## RCO PROJECT: 16-1559 RST, MID-SPENCER ESTUARY RESTORATION

Sponsor: Snohomish County Public Works

### Request:

Snohomish County is requesting Snohomish Basin Chinook Salmon Recovery Forum approval of proposed scope change elements in the final construction design plans. This scope change request will go to the RCO and NOAA. This scope change request is to **eliminate the channel construction metric of up to 3200'**.

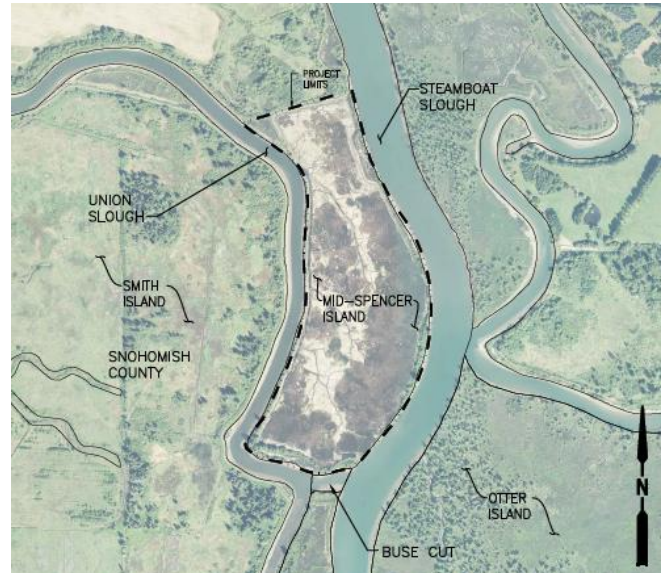
Continued observation of historically breached sites at Mid-Spencer and elsewhere in the Snohomish River estuary during the multi-year project design phase is informing the following two recommendations for finalizing restoration design

- Eliminate excavation of additional interior channels because the channel network geometry has already achieved design objectives.
  - Channel networks with total channel surface area and length comparable to unaltered reference locations nearby, such as at Otter Island (Based on Hood, 2014 methods)
- Relocate three remnant dike breach segments because the sites have already achieved design objectives
  - Natural degradation of the remnant dike has occurred at these locations

1. Eliminate excavation of additional interior channels. Metric up to **3200'**
2. Relocate 3 naturally developed breach locations to new locations
